**DESIGN REVIEW COMMISSION
MINUTES
JUNE 27, 2019
UPPER LEVEL, CONFERENCE ROOM # 6
710 E. MULLAN
12:00 pm**

1. Applicant: Donald Smock
 Location: 1008 E. Mullan Avenue
 Request: For An Early Design Consultation With The Design Review Commission For A
 Two Story Four (4) Unit, Townhome In The Do-E Infill Overlay District.

FROM: TAMI STROUD, PLANNER
DATE: SEPTEMBER 5, 2019
SUBJECT: DR-1-19: REQUEST FOR A SECOND MEETING WITH THE DESIGN REVIEW COMMISSION FOR A TWO STORY, FOUR UNIT TOWNHOME PROJECT IN THE DO-E INFILL OVERLAY DISTRICT.

RIGHT & LEFT ELEVATIONS (WITH 3:12 ROOF PITCH):

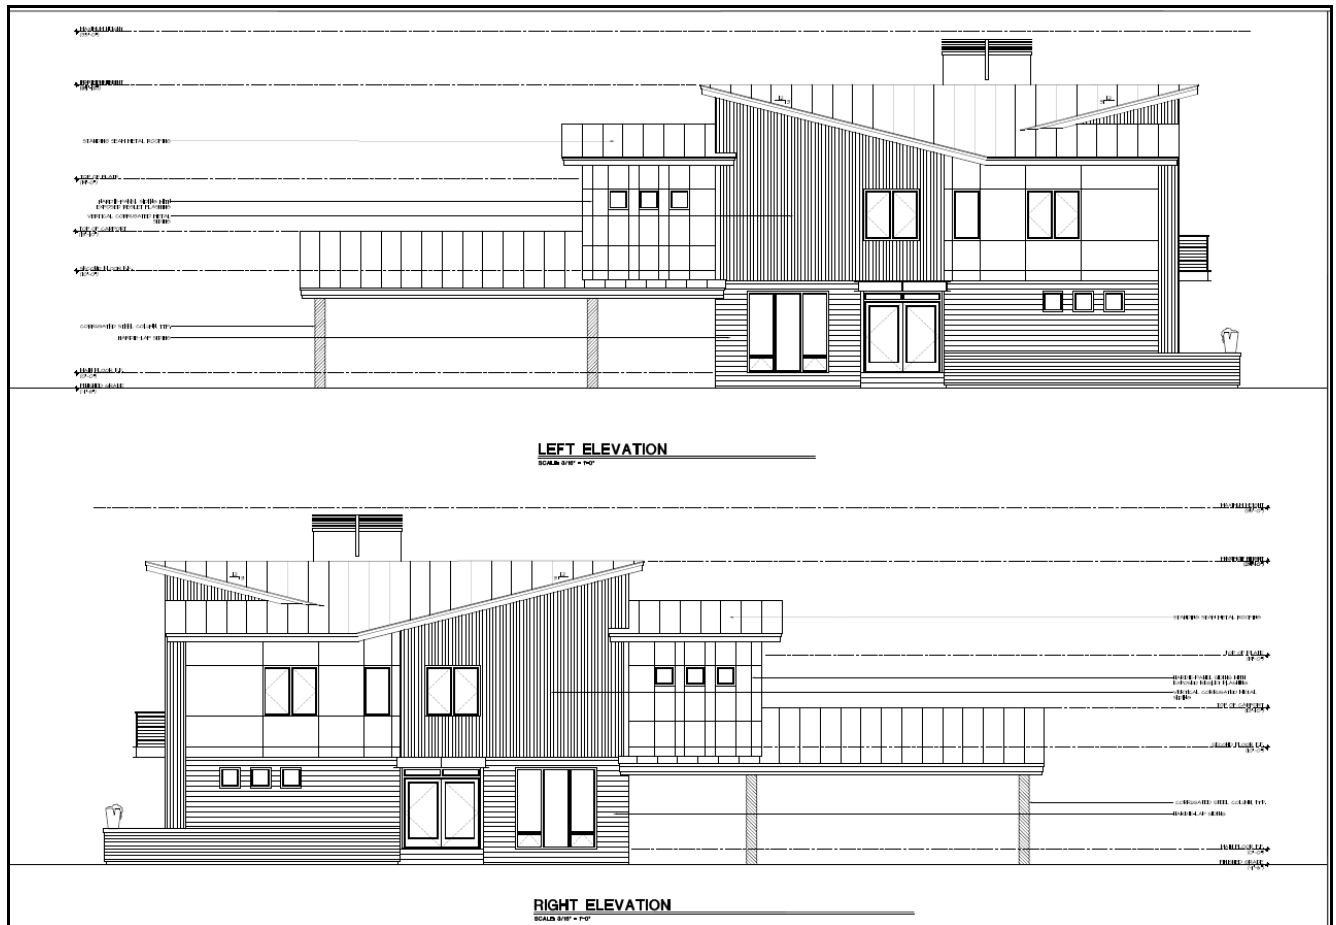
The applicant has requested a Design Departure for the Design Guideline requiring a minimum slope of 4:12 pitch and has requested the approval of a proposed 3:12 pitch for both the 4-unit townhome structure and the carports located in the rear portion of the subject property. The applicant has provided two conceptual elevations showing the design change between the 3:12 pitch and the 4:12 pitch, noting that the 4:12 pitch increases the roof 2+ feet, but is still within the allowed height limit of 35’ in the DO-E. The 3:12 pitch reduces the building height and addresses concerns regarding the possible glare from the metal roof.
